P.O.#: V43683
ORDER #: 80868119
MODEL: EPE500

PROPRIETARY NOTICE THIS DRAWING CONTAINS CONFIDENTIAL AND TRADE SECRET INFORMATION. IS THE PROPERTY OF INGERSOLL-RAND CO. AND IS GIVEN TO THE RECEIVER IN CONFIDENCE. THE RECEIVER BY ACCEPTANCE AND RETENTION OF THE DRAWING ACCEPTS THE DRAWING IN CONFIDENCE AND AGREES THAT, EXCEPT AS AUTHORIZED IN WRITING BY INGERSOLL-RAND CO. IT WILL (1) NOT USE THE DRAWING OR ANY COPY THEREOF OR THE CONFIDENTIAL OR TRADE SECRET INFORMATION THEREIN; (2) NOT COPY THE DRAWING; (3) NOT DISCLOSE TO OTHERS EITHER THE DRAWING OR THE CONFIDENTIAL OR TRADE SECRET INFORMATION THEREIN; AND (4) UPON COMPLETION OF THE NEED TO RETAIN THE DRAWING OR UPON DEMAND, RETURN THE DRAWING, ALL COPIES THEREOF, AND ALL MATERIAL COPIED THEREFROM.		TITLE PLAN, FOUNDATION REMOTE COOLED UNIT	
SIZE A1	DWG NO. 24027609	REV A	
SCALE NTS	SHEET 3 OF 3

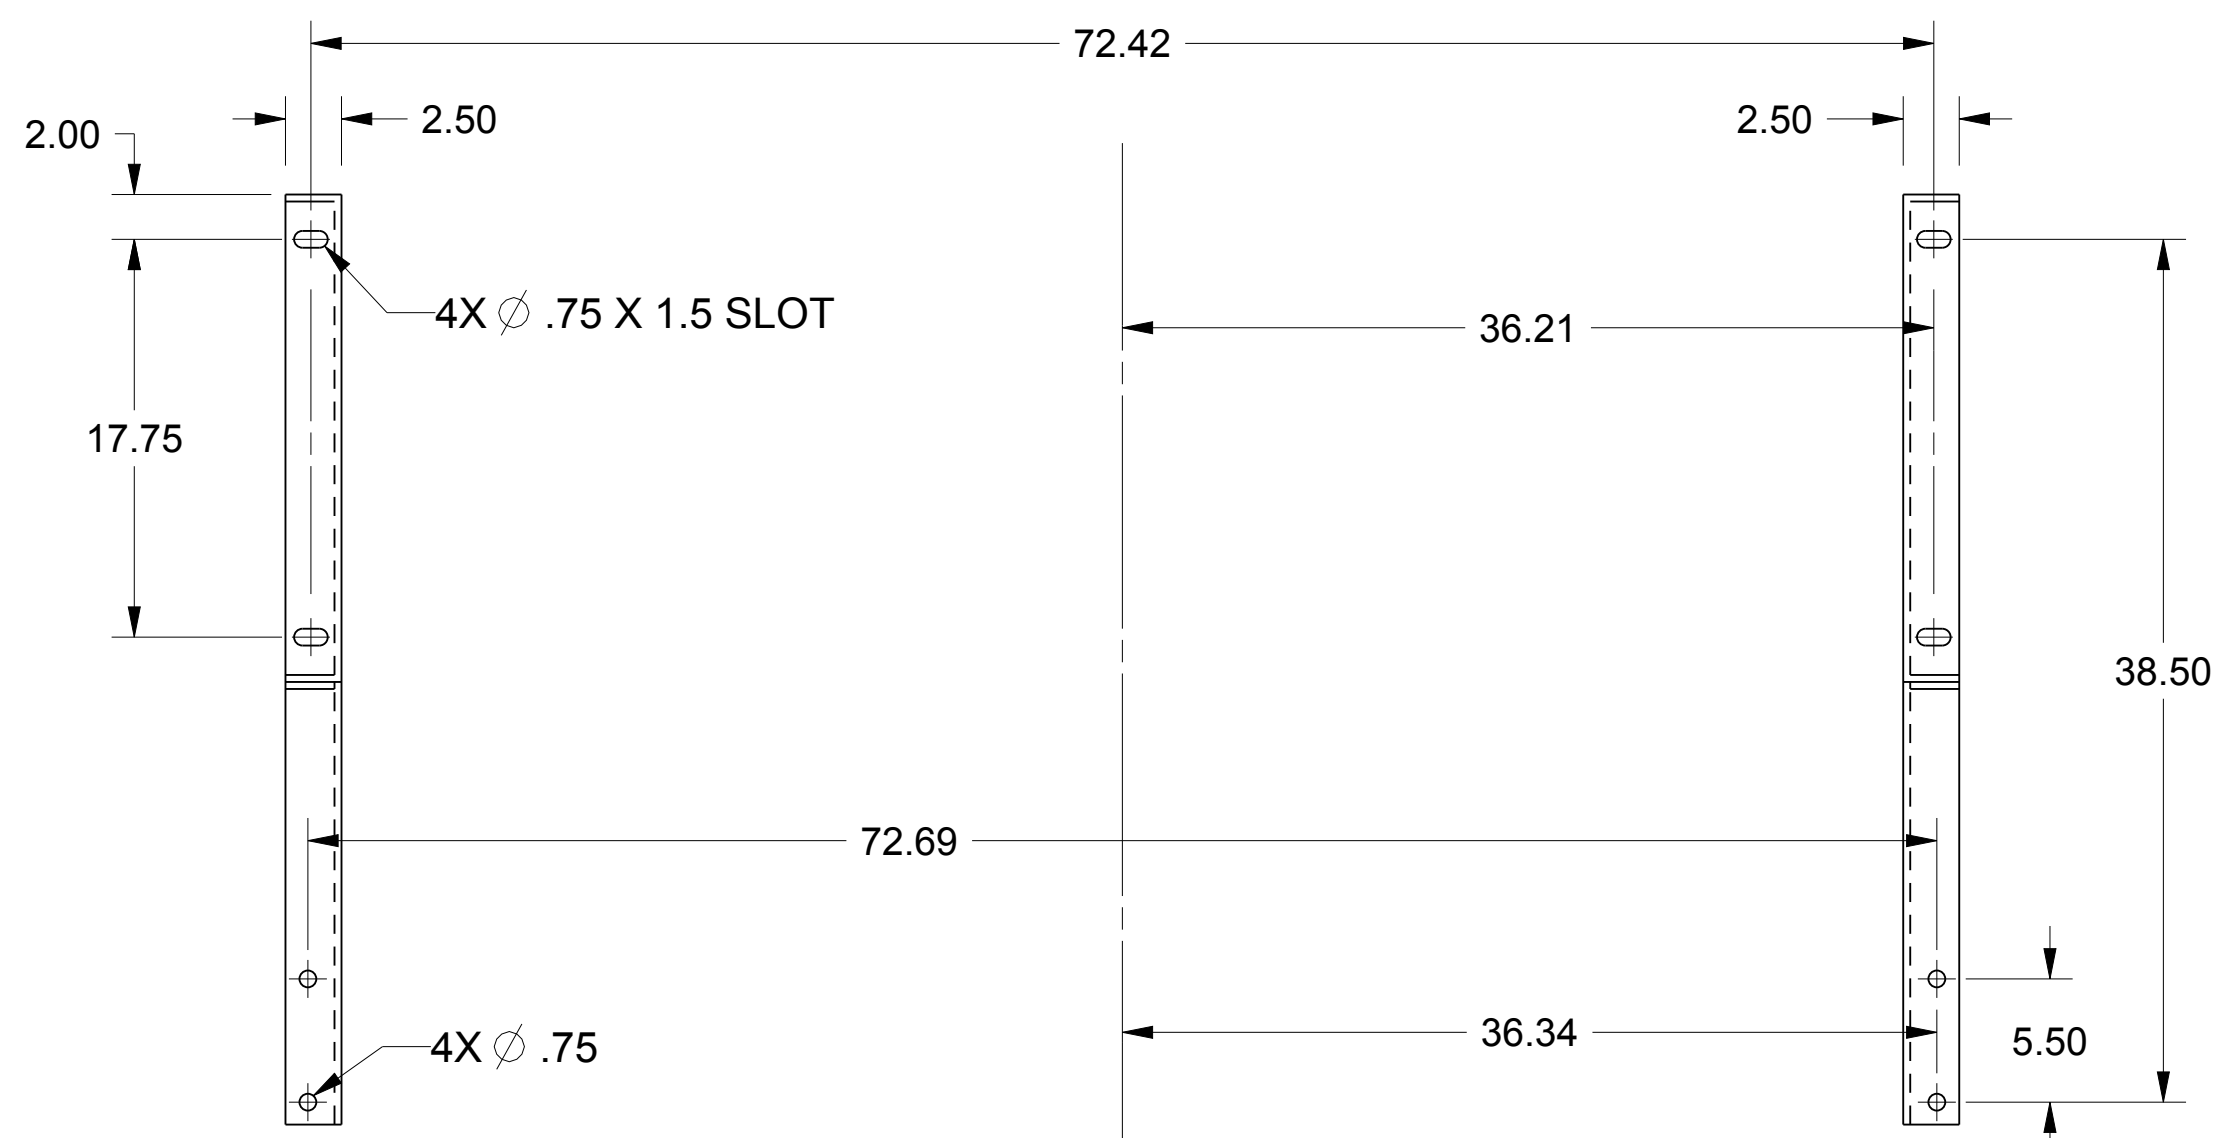
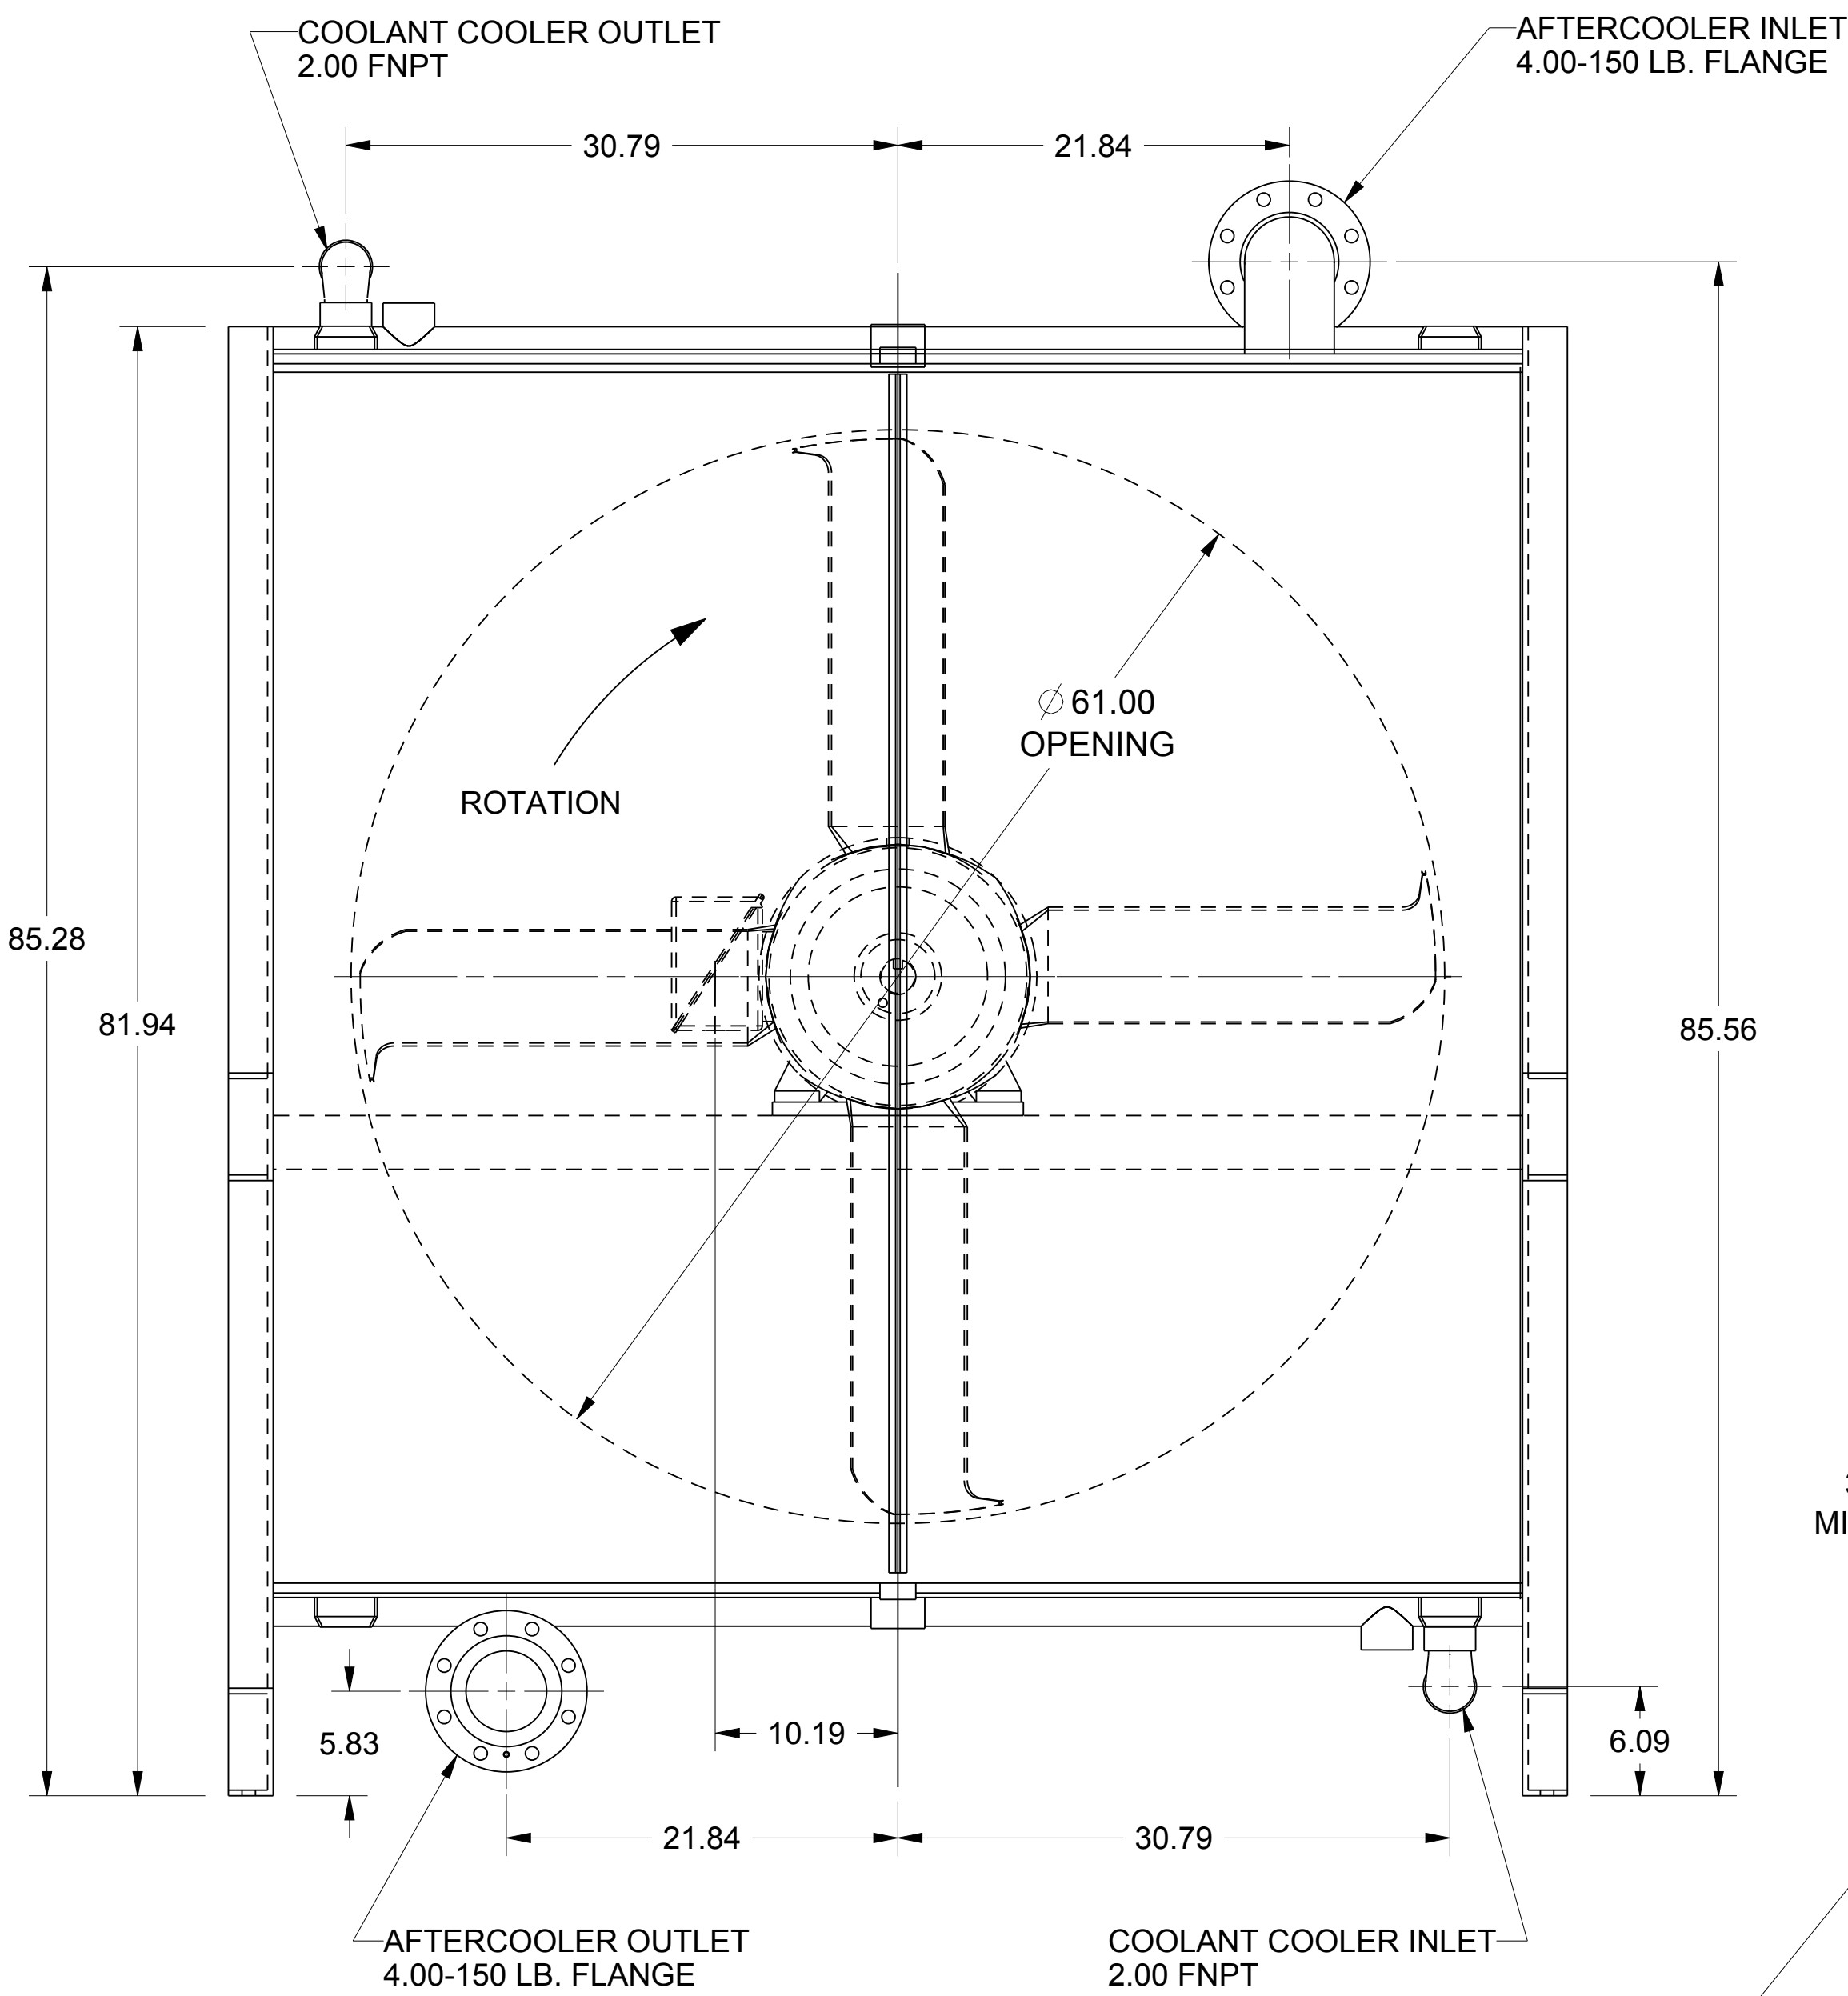
FLEX COUPLING REQUIRED AT
AFTERCOOLER INLET & OUTLET

REJECTED

Submittal is incorrect to such an extent that material is unacceptable or is incomplete to such an extent that a complete review cannot be made.

RESUBMIT IN ACCORDANCE WITH REQUIREMENTS OF THE CONTRACT DOCUMENTS
